# **A303 Sparkford to Ilchester Dualling**

## **Project TR010036**

### **Deadline 4**

### **Summary**

AKT 7

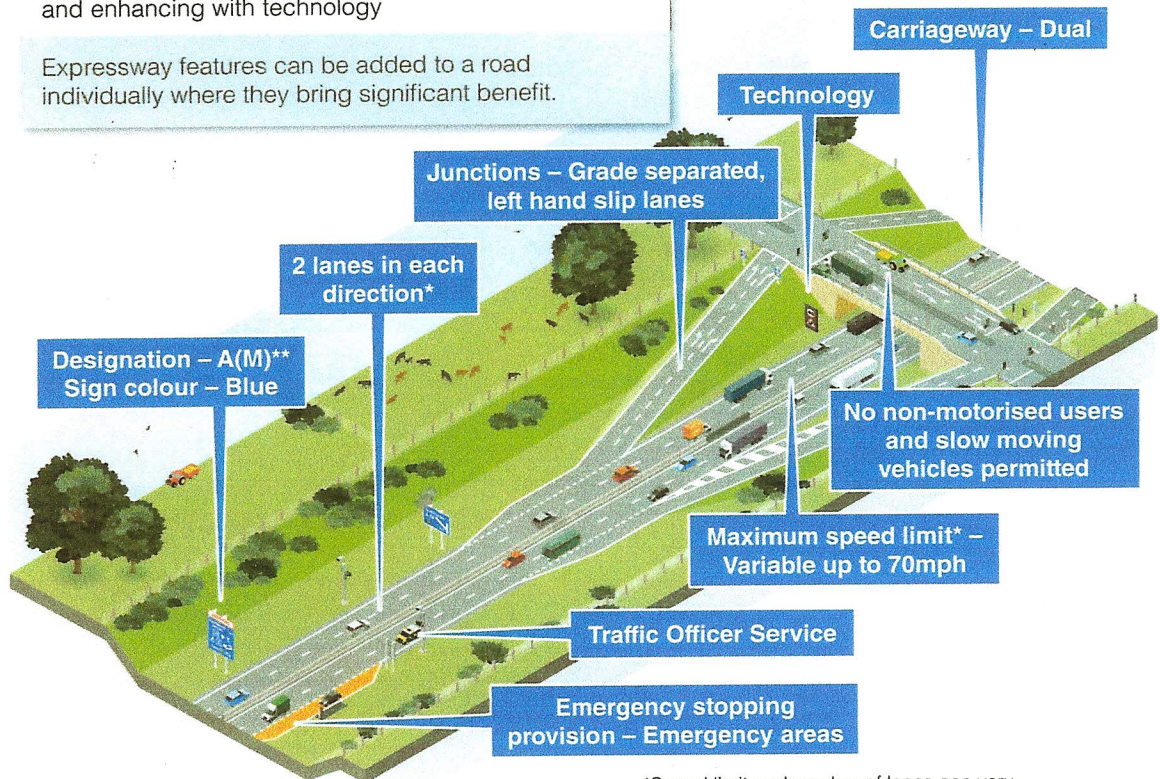
③ CONSTRUCT PHASE I  
EASTBOUND CARRIAGEWAY

① EXISTING A303  
REMAINS IN USE UNTIL  
PHASE I OF NEW EASTBOUND  
CARRIAGEWAY COMPLETED

USE THIS AREA  
AS THE COMPOUND

WHY HAVE PERSONNEL,  
VEHICLES, PLANT +  
MATERIALS CROSSING  
A + B WITH A303 BOTH LIVE  
TRAFFIC WHEN VAST  
MAJORITY OF WORK IS ON THE  
OTHER SIDE OF BOTH

WHEN ③ COMPLETE  
ALL A303 TRAFFIC TO  
DIVERTE ONTO NEW  
CARRIAGEWAY

# AKT 8

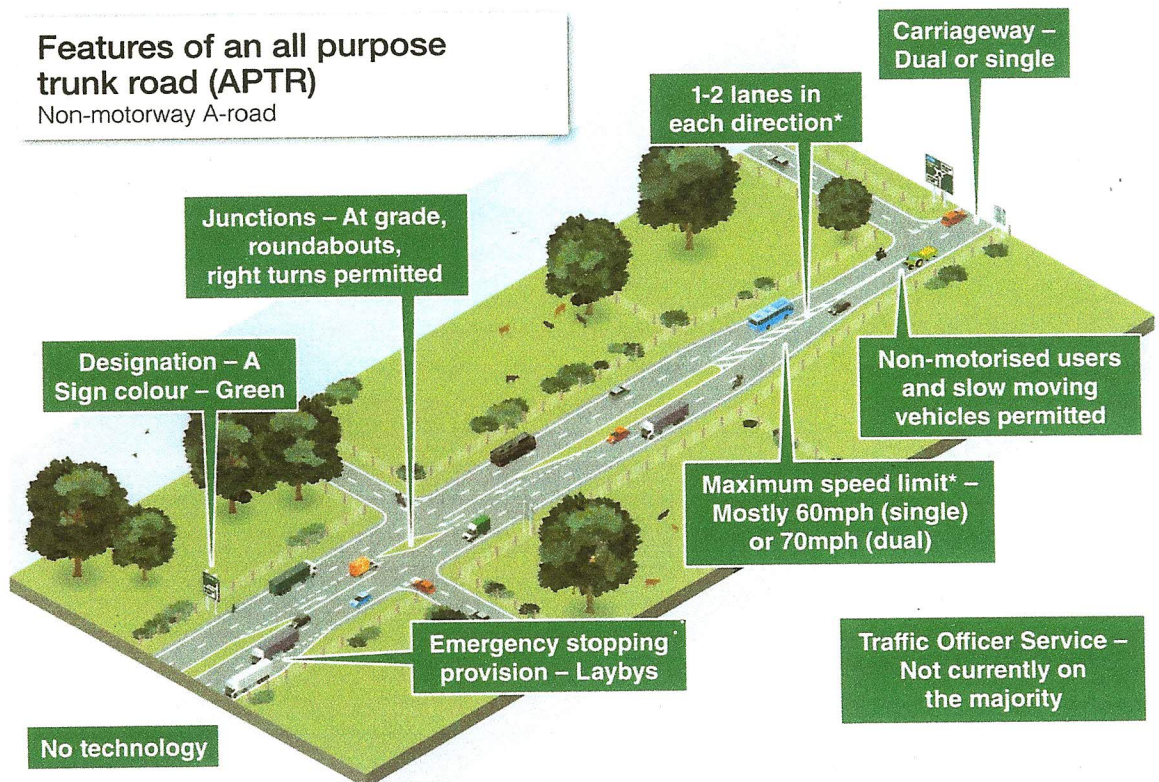
**The Applicant** states that an expressway standard has not yet been published. In Highways England 'Strategic Road Network Initial Report' dated December 2017. There are numerous references to the A303 a Planned and potential expressway. At page 59 (see AKT 8 attached) there is an illustration of the features of an expressway. Save for the signage being blue instead of green and a Traffic Officer Service it appears that there is little to stop this very short section of trunk road being upgraded to be compliant with expressway proposals.
